**PLANNING STAFF REPORT**  
**File No. 1-NB-15**

- A. **APPLICANT/PROPERTY OWNER:** John Lee (John Lee, Denny Han, and Dale Johnson (authorized representatives), Nye Hotel, LLC (owners)).
- B. **REQUEST:** Consideration by the Planning Commission of a request for design review under the design guidelines for the Historic Nye Beach Design Review District to review the plans for a 10,375 sq. ft. addition that includes 16 guest rooms, a lobby addition, laundry addition, and a new spa building at the Inn at Nye Beach (formerly the Greenstone Inn). An existing two-story building on the property, which contains 3 guest rooms, a fitness room and laundry room will be demolished. The new addition will be constructed in its place. It will be three stories in height, and will extend over the existing driveway to tie into the existing hotel. The building plans list the peak height of the addition at 47ft., 3-in., and illustrate that the building footprint will be 138-feet in length.

INN AT NYE BEACH ADDITION  
729 NORTHWEST COAST STREET  
NEWPORT, OREGON 97365

PROJECT PHASE:  
PLANNING SUBMITTAL

2 LANDSCAPE PLAN - BUILDING FRONTAGE

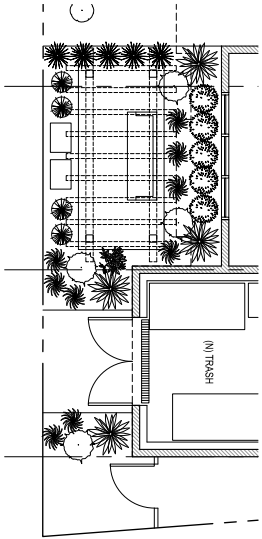
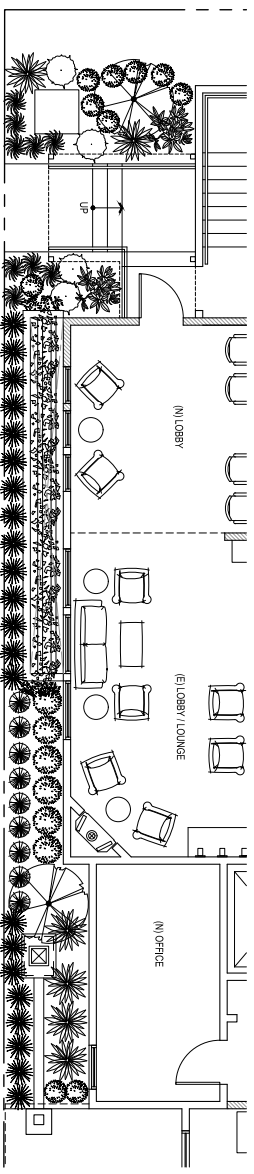
This guideline relates to off-street parking and generally requires that when off-street parking is provided on site that it be provided at the sides or rear of the building, or below street grade. The applicant's site plan shows that off-street parking needs will be met with the existing basement level garage and new "at grade" surface parking stalls that will be located between the hotel building and edge of the bluff, out of view from pedestrians and vehicles traveling along NW Coast Street (ref: Sheet SP-1, Attachment "A-2"). New surface parking will be visible from adjoining residential areas to the north and south. Along the north property line the applicant is proposing landscaping; however, the plantings are primarily

shrub and groundcover species that may not be sufficient to provide meaningful screening (ref: Sheet L-1, Attachment "A-2"). The Commission may want to require that the applicant adjust the landscaping plan to provide more effective screening at this location. Similarly, surface parking may be visible from residential property to the south, since it extends west past the retaining wall. There doesn't appear to be any landscaping proposed at this location and it is likely that the existing fence will need to be removed to accommodate the proposed site improvements. The Commission may want to have the applicant supplement the plantings or fencing at this location to provide more effective screening.

1 ROOF PLAN

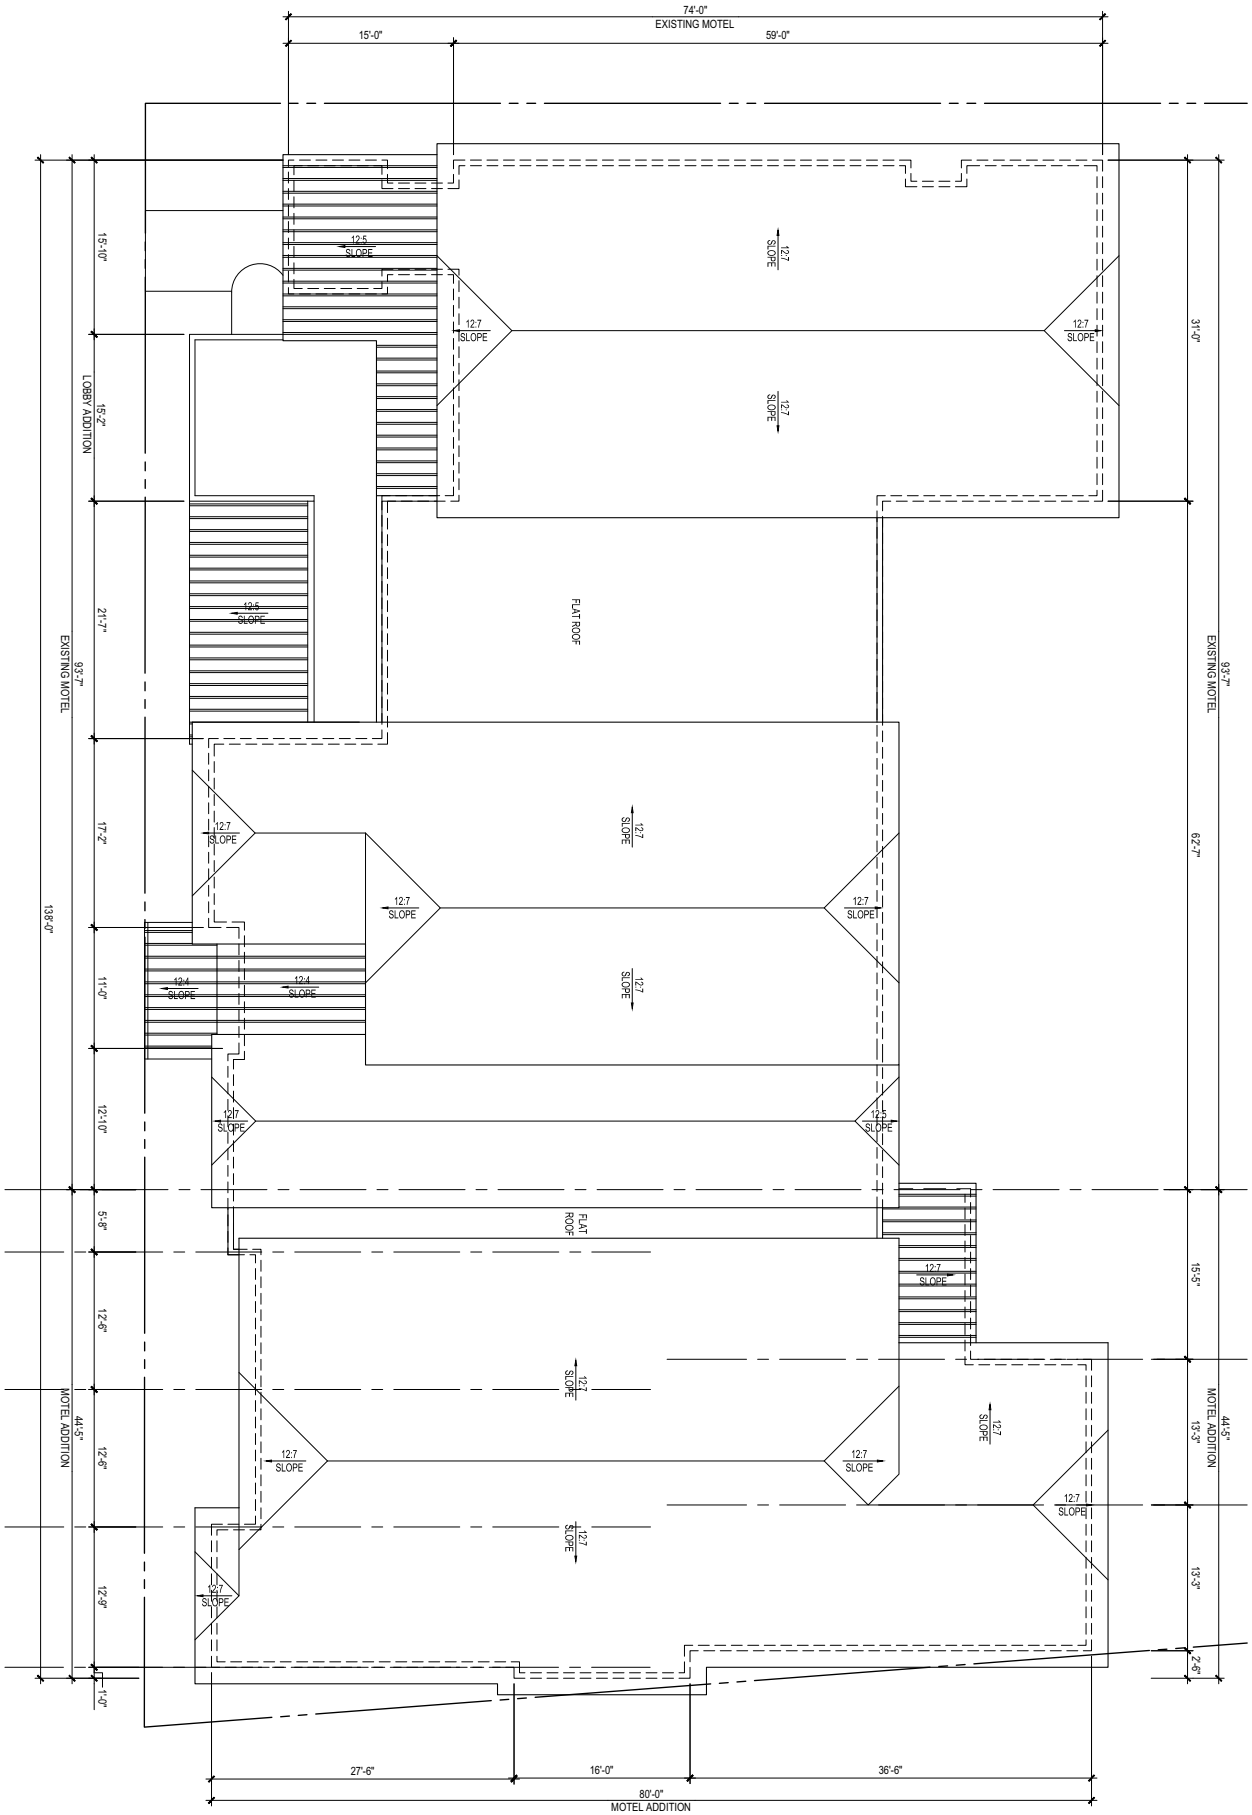
The hotel roof plan (Sheet A-4, Attachment "A-2") shows that the predominant roof form is a clipped gable roof with a 7:12 pitch. That same roof form has been used for the addition. Shed roof elements have been incorporated into the lobby addition at a 5:12 pitch. The shed roof at the entrance is listed at a 4:12, which does not meet the guideline; however, the perspective renderings show that it matches the slope of the other shed roof features (ref: Sheets A-8 and A-9, Attachment "A-2"). The Planning Commission may want to have the applicant clarify this discrepancy.

6 SPA BUILDING - ROOF PLAN

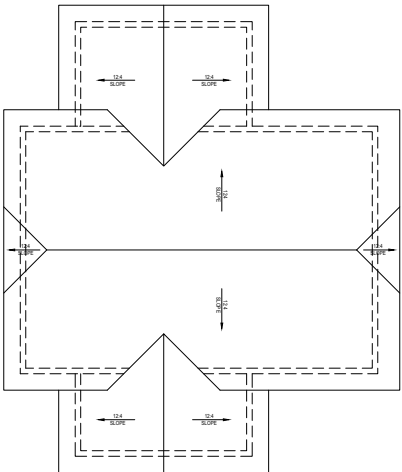
This guideline applies to the spa building as well. The roof plan for that structure shows 4:12 pitch (ref: Sheet A-7, Attachment "A-2"). The slope of that roof will need to be increased to 5:12 or greater in order for the guideline to be met.
